March 25, 2024
Subject: Pavement Rehabilitation, Pavement
Milling, Hot Mix Asphalt Overlay
State WIN: 027022.00
Location: **Brunswick & Freeport
Amendment No. 1**

STATE OF MAINE
 DEPARTMENT OF TRANSPORTATION
 FEDERAL PROJECT 2702200
 WIN 27022.00
 HIGHWAY PLANS

FREEPORT-BRUNSWICK
 INTERSTATE 295 NORTHBOUND & SOUTHBOUND
 TYPICAL SECTIONS

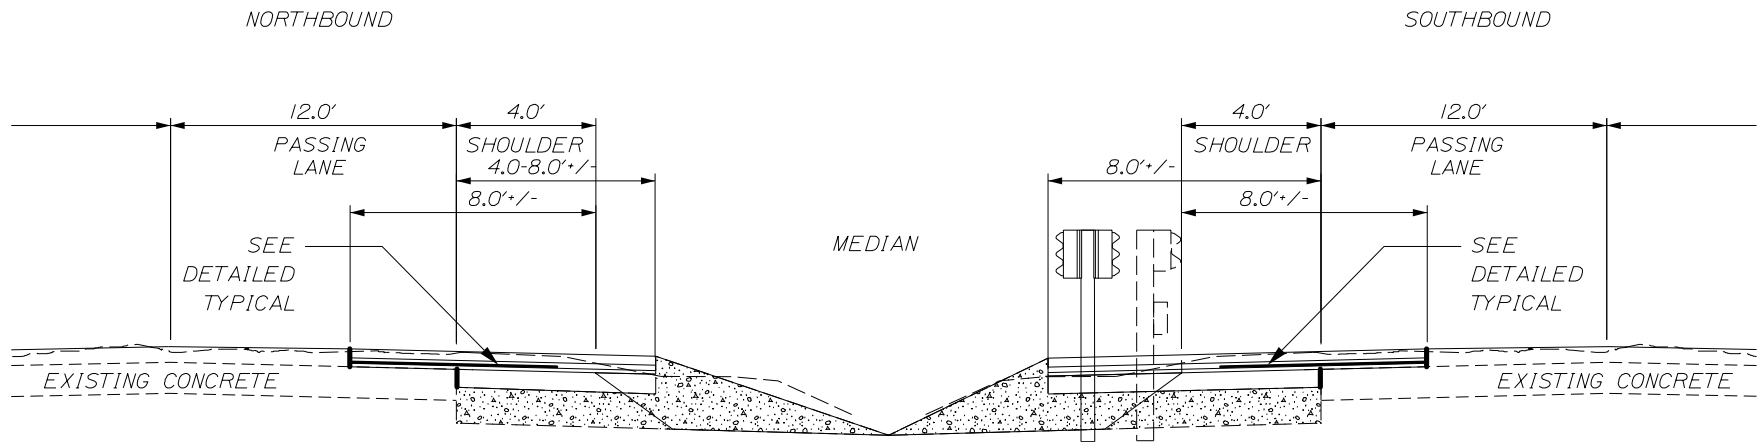
Question: Would it be possible to provide a typical section showing both the NB and SB with the median?

Response: Please see attached typical section.

4 1/2" +/- MILL
 4" BASE PAVEMENT
 1" +/- HMA SHIM
 1 1/2" BASE PAVEMENT

SEE CONSTRUCTION NOTES FOR STATIONING OF TREATMENT
 DIFFERENCES IN ELEVATION FOR NORTHBOUND AND SOUTHBOUND BARRELS
 SHALL BE DETERMINED IN THE FIELD BY THE RESIDENT
